Figure 2.12f
Infrastructure Design Review
- Turbine 06

Tangy IV Wind Farm
S36C EIA Report 2026
Proposed Varied Development

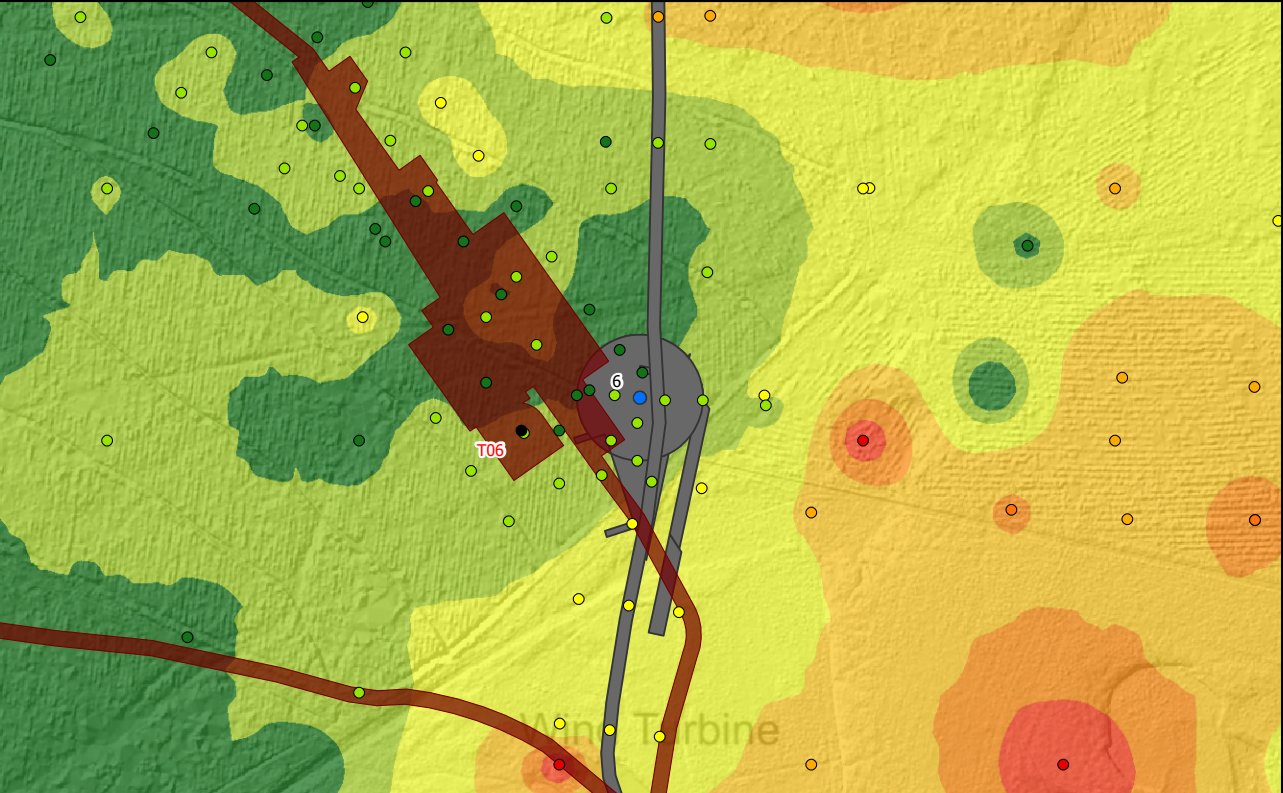
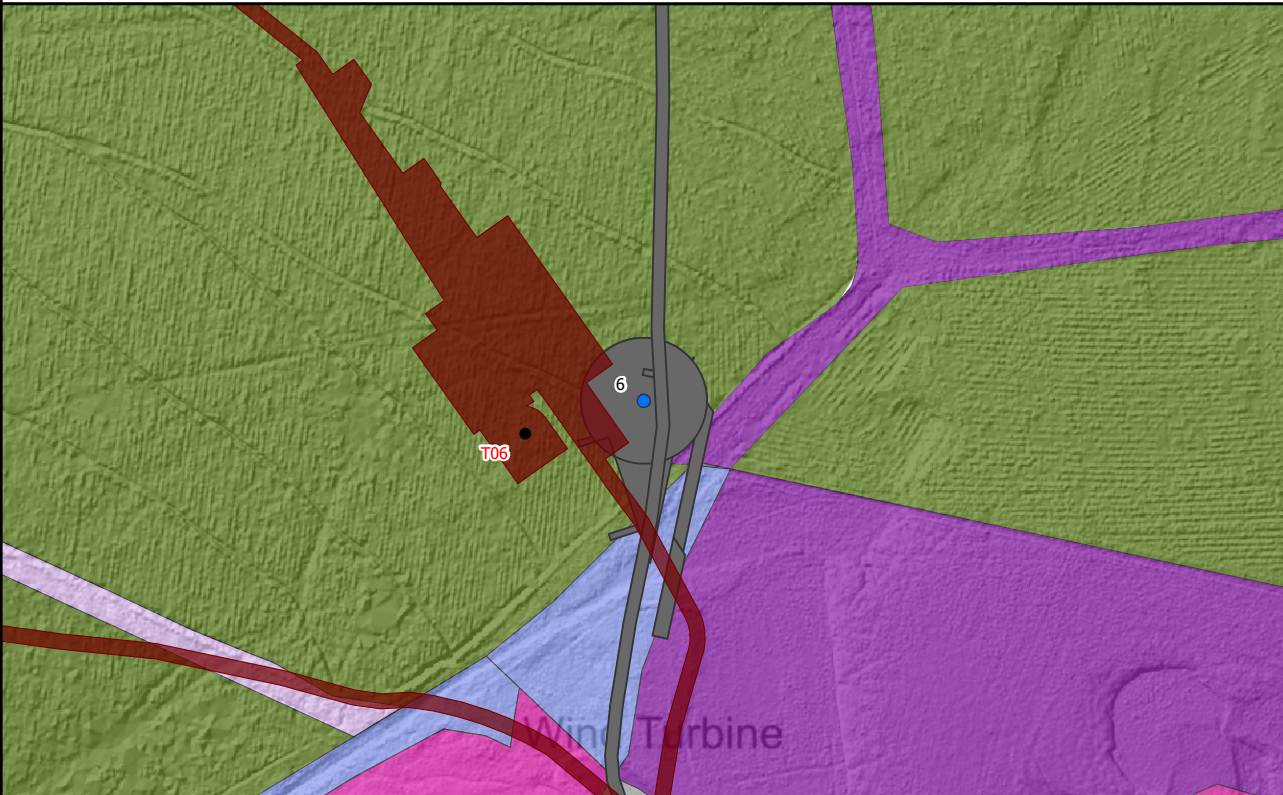
T06: Reason for Moving: The turbine location has been moved to reduce the impact on deeper pockets of peat on the site.

Engineering: The track alignment has been changed to avoid area of deeper peat. As a result the track now follows the contour lines reducing gradients on site. This has the additional benefit of reducing the impact of the top of the hill that would be necessary for the consented development.
The plan for turbine component deliveries is to drive through the hardstand and turn the delivery vehicles using one of the junctions to the north of the site. This will allow the delivery vehicles to approach the turbine location in a forward direction to off load components. The vehicle can then exit the site by driving back down the main spine road.

Geology Impacts: The infrastructure now avoids deeper areas of peat than the consented track and hardstands.

Ecology Impacts: The turbine and infrastructure is located in an area of commercial coniferous forest that will be clear felled as part of the project scope.

Hydrology Impacts: There are no water buffers within the area adjacent to the turbine location.
